Addendum No.: 01

Date Of Addendum: 3/16/2021

**BUSINESS SCHOOL INSTRUCTIONAL FACILITY
SOUTHERN CT STATE UNIVERSITY
BI – RS– 337**

The following clarifications are applicable to drawings and specifications for the project referenced above.

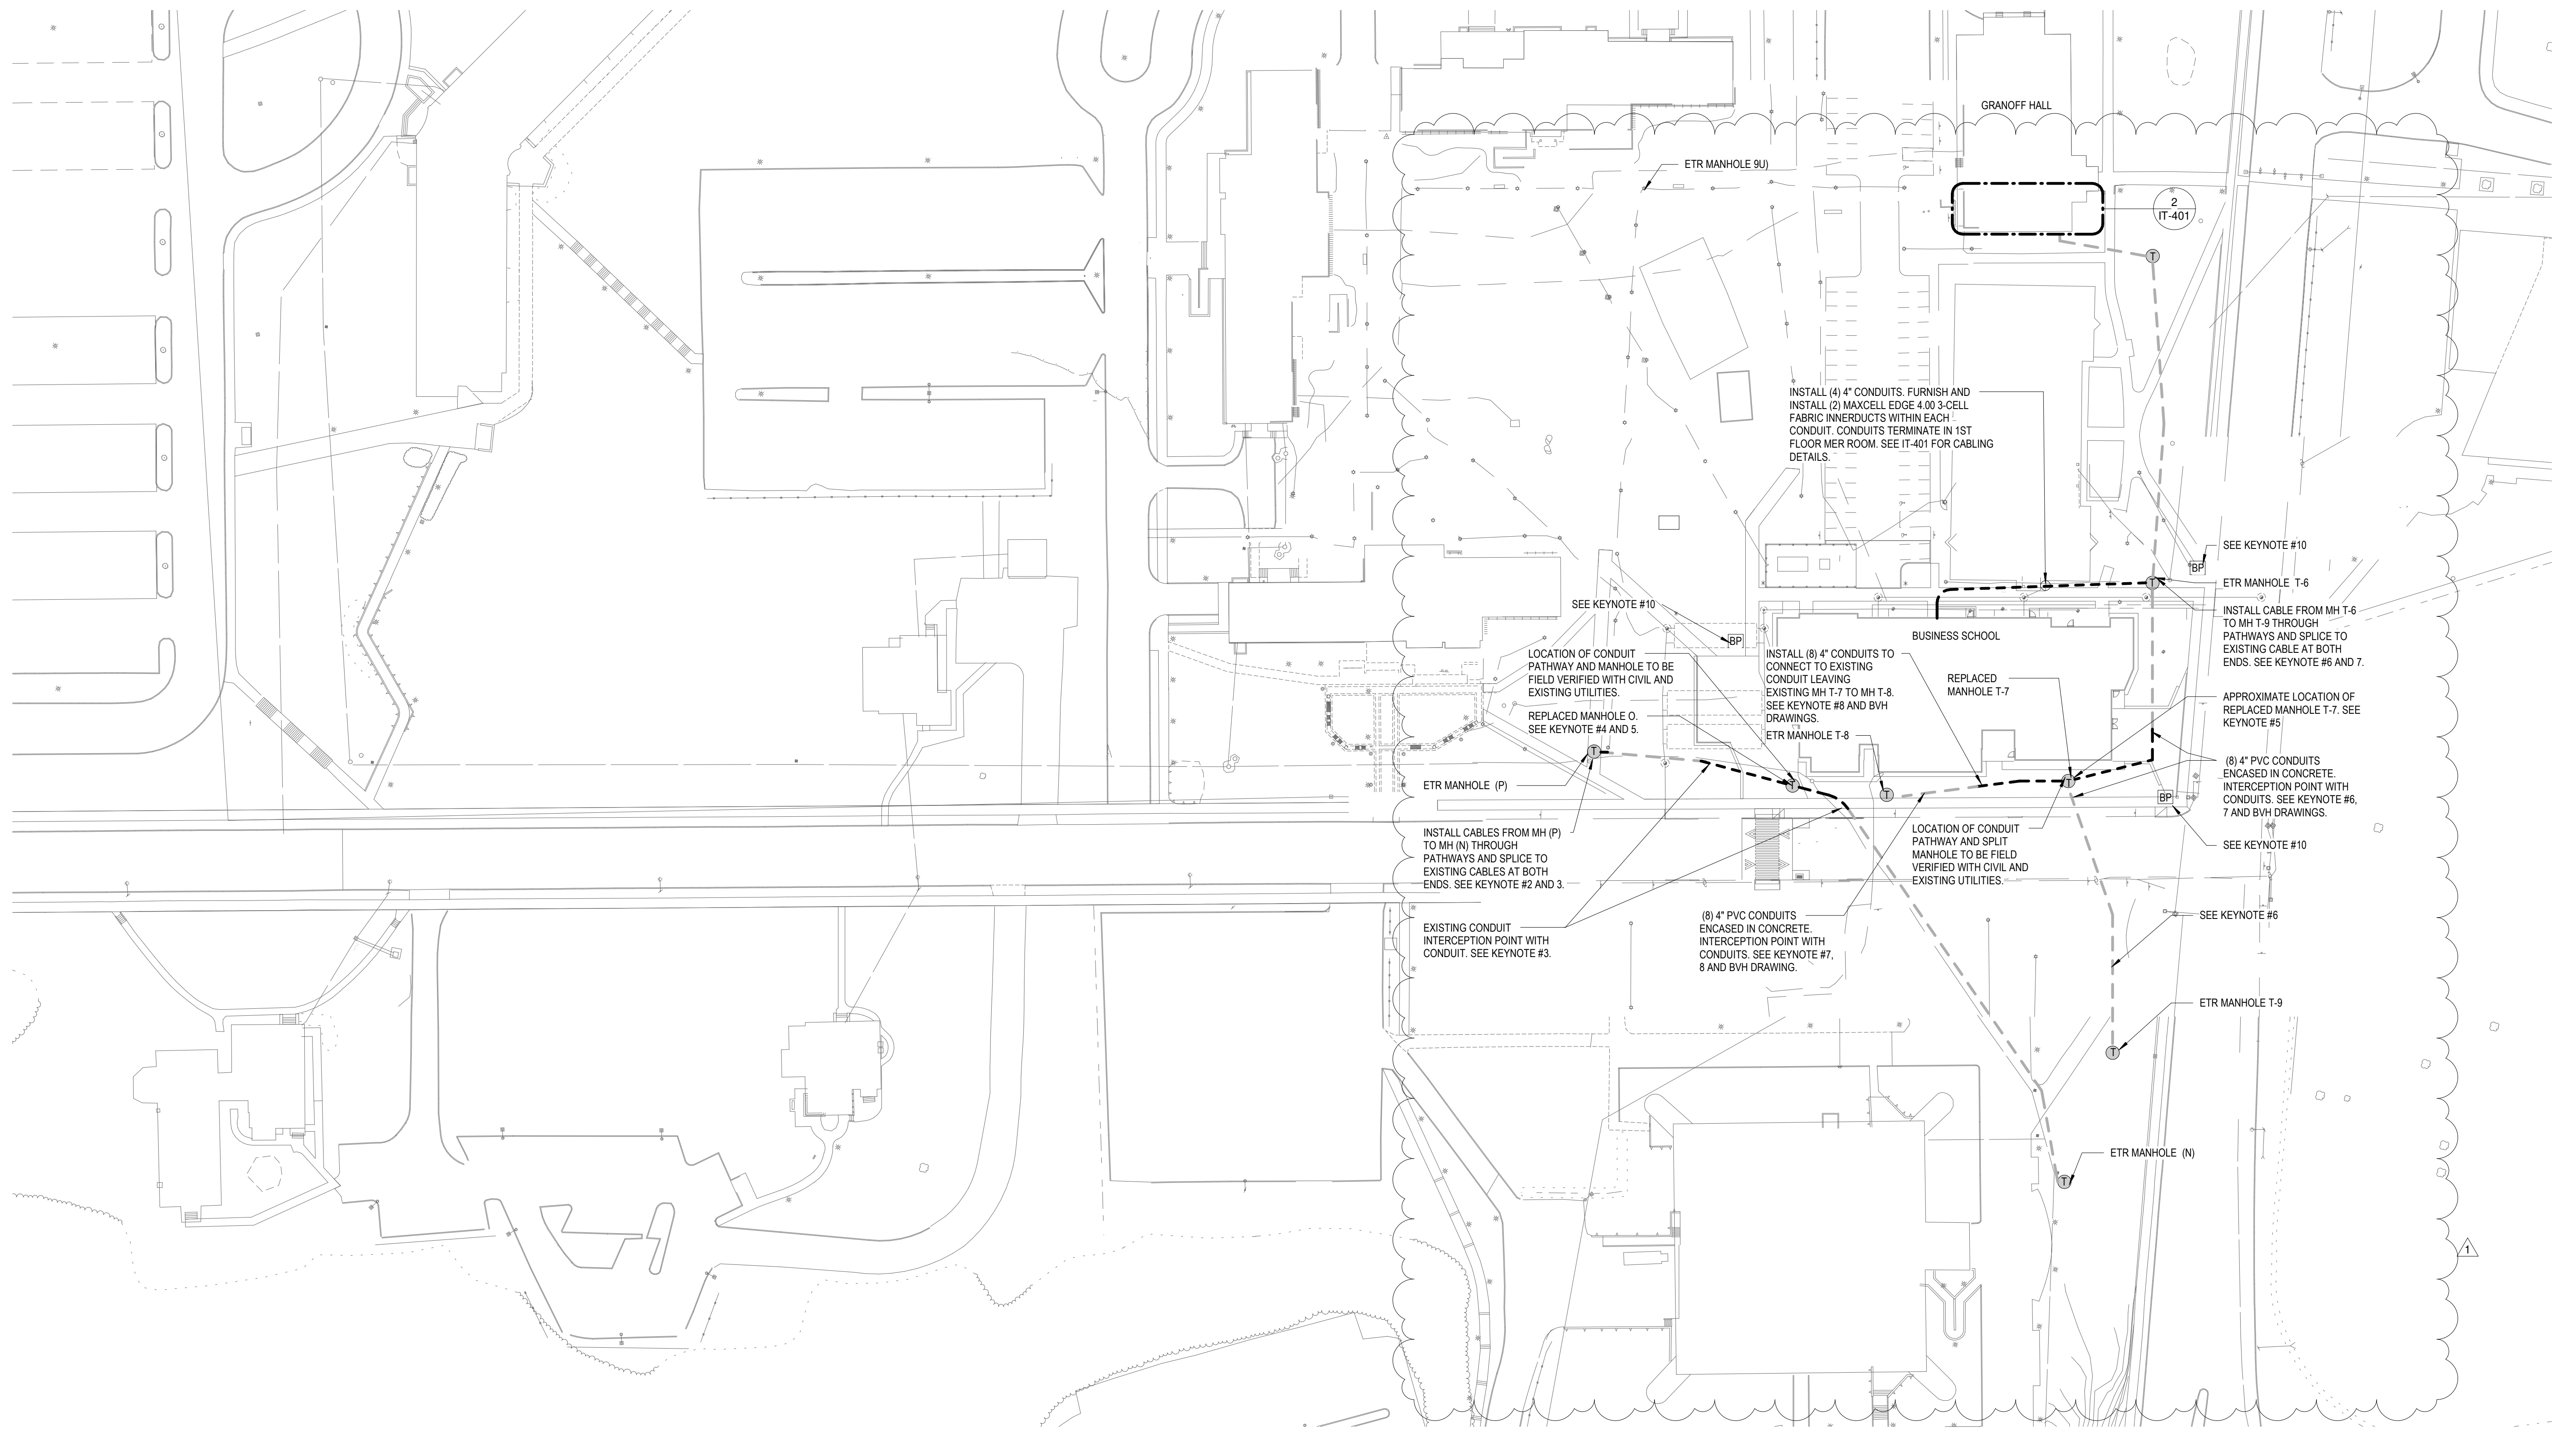
On drawings IT-011, revised scope of IT manhole work and reference notes.
